Bicycle Advisory Committee
CORRESPONDENCE

2015 DTX draft SEIR

SFCTA March 14 Board meeting Item #12 update on the Railyard Alternatives

Observation: the Townsend (Baseline) and Third Street locations do not address the top community priorities:

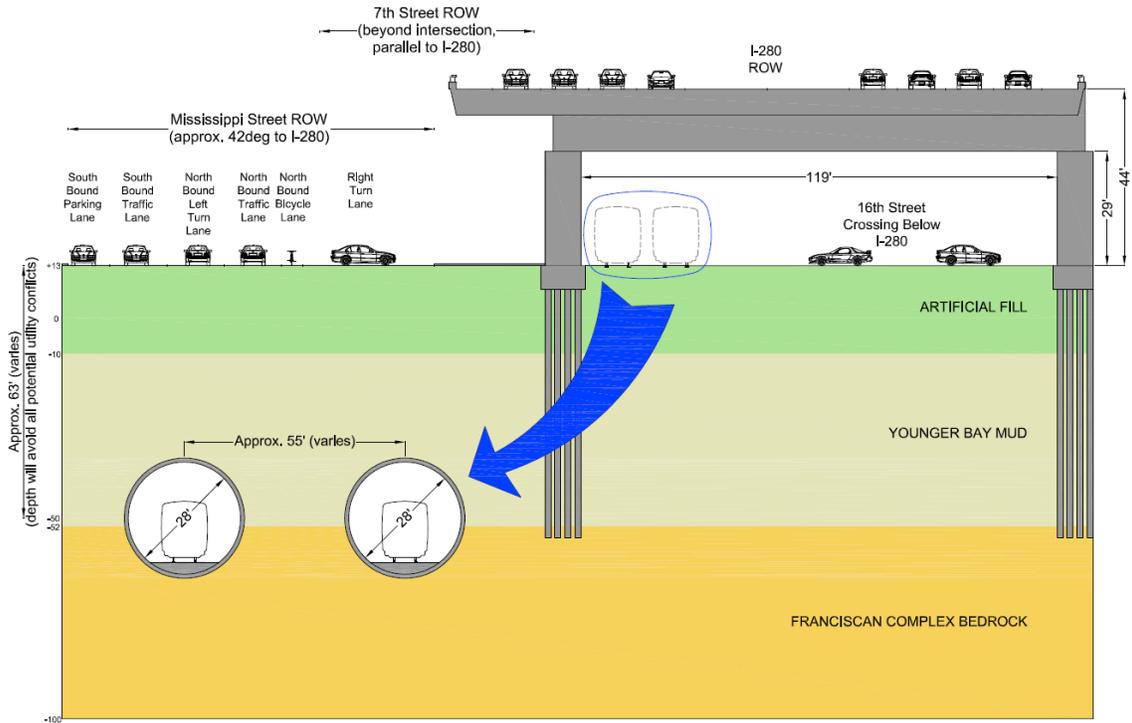
- Improved Local Transit Connections
- Improved Regional Transit Connections
- Neighborhood connectivity

Recommendation: the RAB study should consider the 7th Street location (between 16th and Townsend) which has the following characteristics:

- Best local transit connections (22 Filmore and N & T-Third loop extensions).
- Epicenter of the most rapidly growing areas of the City including South of Market, Mission Bay and Showplace Square/Lower Potrero Hill.
- Lowest construction impacts.
- Station can act as a substitute for the existing 22nd and 4th & King stations
